DEPARTMENT OF TRANSPORTATION**National Highway Traffic Safety Administration****49 CFR Part 571**

Federal Motor Vehicle Safety Standards; Door Locks and Door Retention Components

ACTION: Final rule; response to petitions for reconsideration; technical amendments.

FIGURE 7 • VEHICLE COORDINATE REFERENCE SYSTEM FOR INERTIAL TESTING

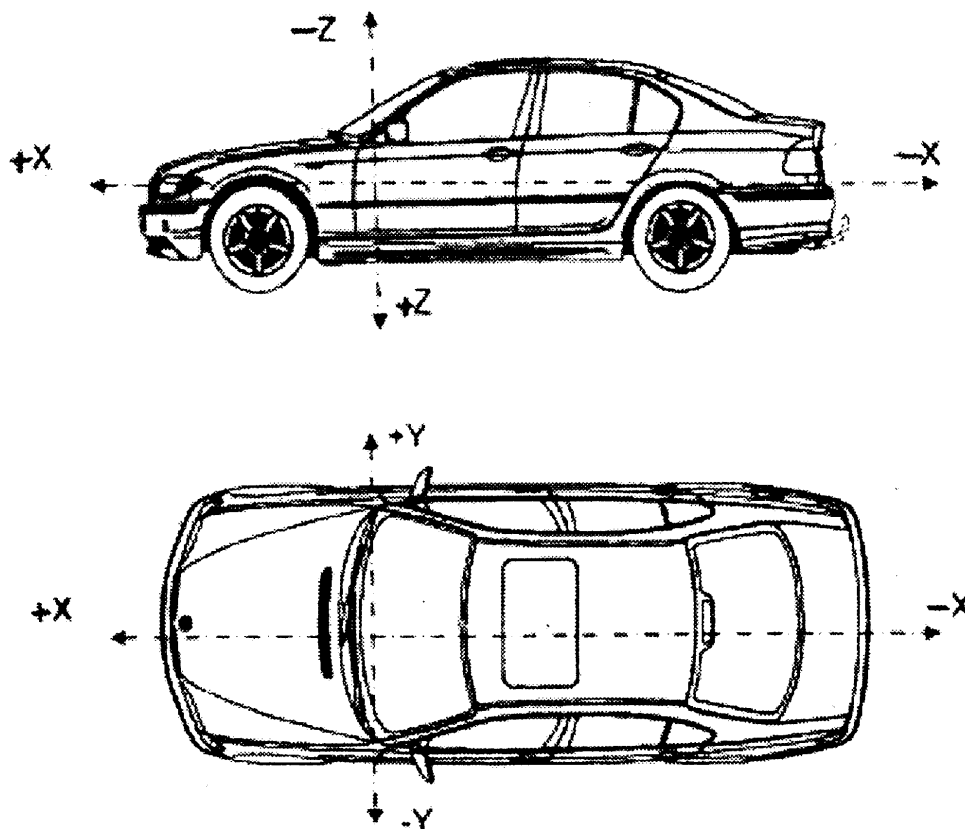
b. Technical Amendment to Figure 7

Prior to the February 2007 final rule, FMVSS No. 206 did not have a figure that graphically displayed the vehicle coordinate reference system to be used for inertial testing. The GTR provided such a figure because part of the GTR referenced various directions with respect to different vehicle axes. The NPRM proposed, and the February 2007 final rule adopted, this same GTR figure as Figure 7.

Although the agency did not receive any comment regarding Figure 7 in response to both the NPRM and the February 2007 final rule, after publication of the final rule NHTSA realized that x-axis and the z-axis in Figure 7 were not consistent with SAE J211 (Instrumentation for Impact Test) or with the sign conventions used in other Federal motor vehicle safety standards such as FMVSS No. 208 and FMVSS No. 214. Therefore, NHTSA is making a technical amendment to FMVSS No. 206 by modifying Figure 7 to be consistent with SAE J211 and the sign convention for other Federal motor vehicle safety standards as follows:
